**GPL - Farmersville Area Reliability Project
– ERCOT Independent Review Final Update**

Ying Li
System Development, Transmission Planning

Regional Planning Group
May 19, 2020

Option 1 (GPL Proposed Solution)

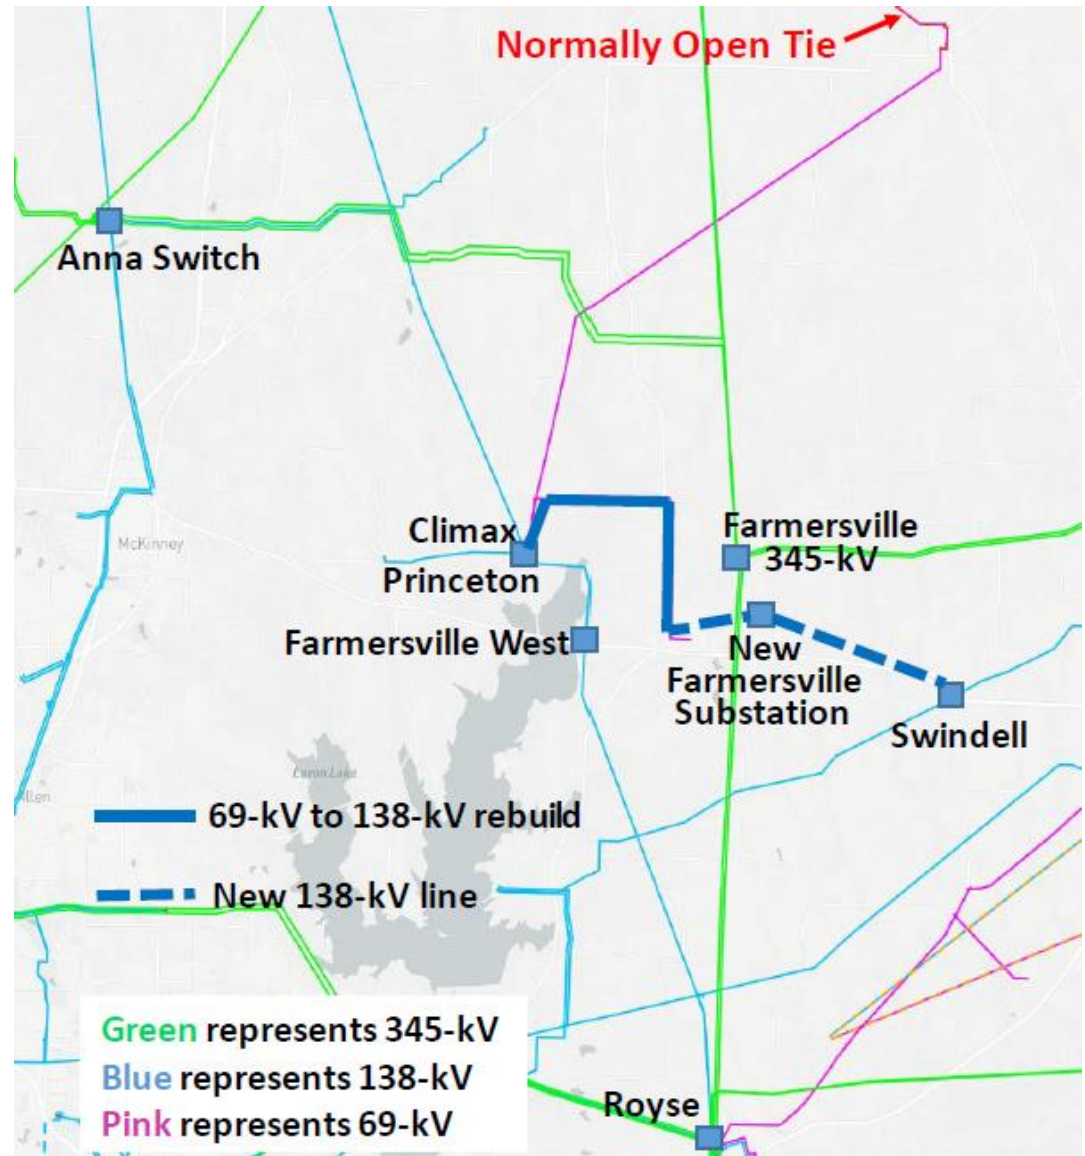
- Build a new Farmersville 138-kV substation
- Rebuild and convert the existing Climax-Farmersville 69-kV line (~ 9 miles) to 138-kV and construct a new 138-kV line (~ 2 miles of new right of way) to connect the converted 138-kV line to the new 138-kV Farmersville substation
- Build a new single-circuit 138-kV line from Swindell to the new Farmersville substation (~ 5 miles)

- **Based on the review of the system performance and the cost estimate of each option , ERCOT recommends Option 1 as the preferred solution**
 - Build a new 138-kV Farmersville substation (about 2 miles east of the existing 69-kV Farmersville substation, which is owned by GPL)
 - Rebuild and convert the existing Climax-Farmersville 69-kV line (~ 9 miles) to 138-kV and construct a new 138-kV line (~ 2 miles of new right of way) to connect the converted 138-kV line to the new 138-kV Farmersville substation with an emergency rating of at least 235 MVA
 - Build a new single-circuit 138-kV transmission line (~ 5 miles of new right of way) from Swindell, which is owned by GPL, to the new Farmersville substation with an emergency rating of at least 235 MVA
- **In accordance with Protocol Section 3.11.4.9(4), ERCOT will not endorse this project as it is needed solely to meet a TSP's criteria**

Option 2

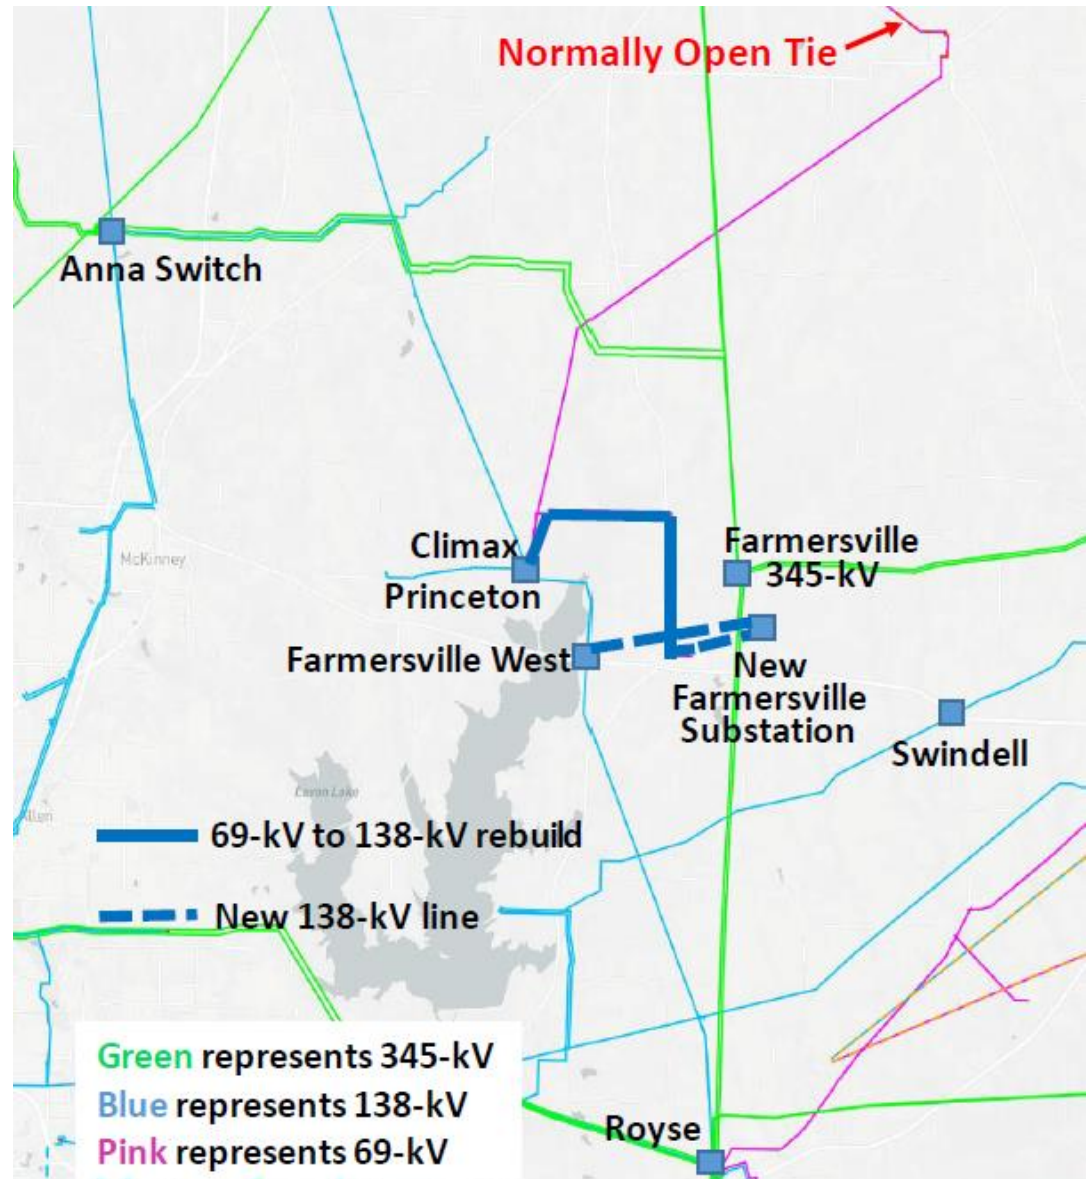
- Build a new Farmersville 138-kV substation
- Rebuild and convert the existing Climax-Farmersville 69-kV line (~ 9 miles) to 138-kV and construct a new 138-kV line (~ 2 miles of new right of way) to connect the converted 138-kV line to the new 138-kV Farmersville substation
- Build a new single-circuit 138-kV line from Farmersville West to the new Farmersville substation (~ 5 miles)

Option 3

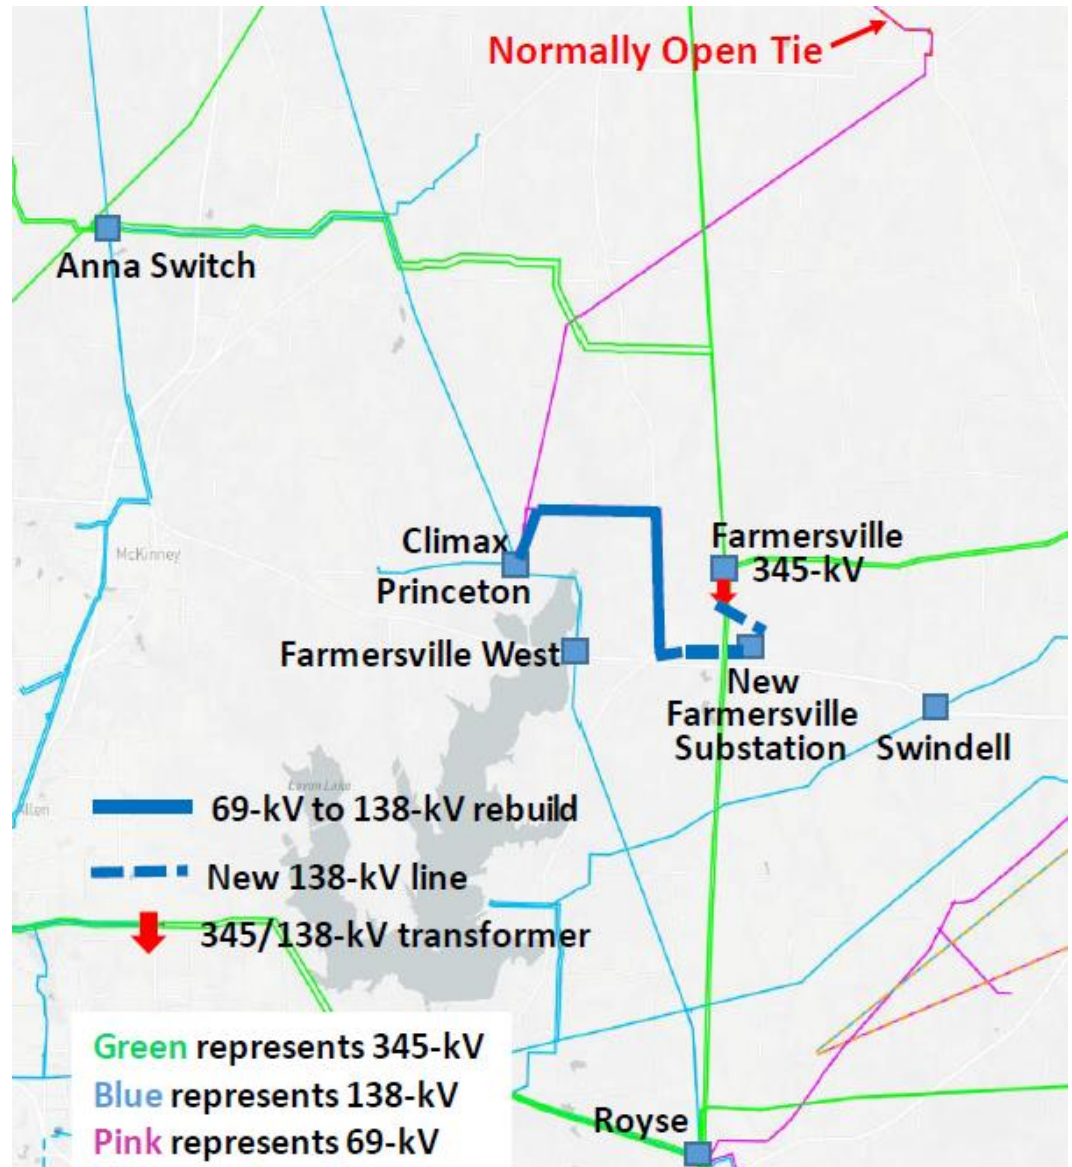
- Build a new Farmersville 138-kV substation
- Rebuild and convert the existing Climax-Farmersville 69-kV line (~ 9 miles) to 138-kV and construct a new 138-kV line (~ 2 miles of new right of way) to connect the converted 138-kV line to the new 138-kV Farmersville substation
- Install one 345/138-kV transformer at the existing Farmersville Switch 345-kV substation
- Build a new single-circuit 138-kV line from Farmersville Switch to the new Farmersville substation (~ 2 miles)
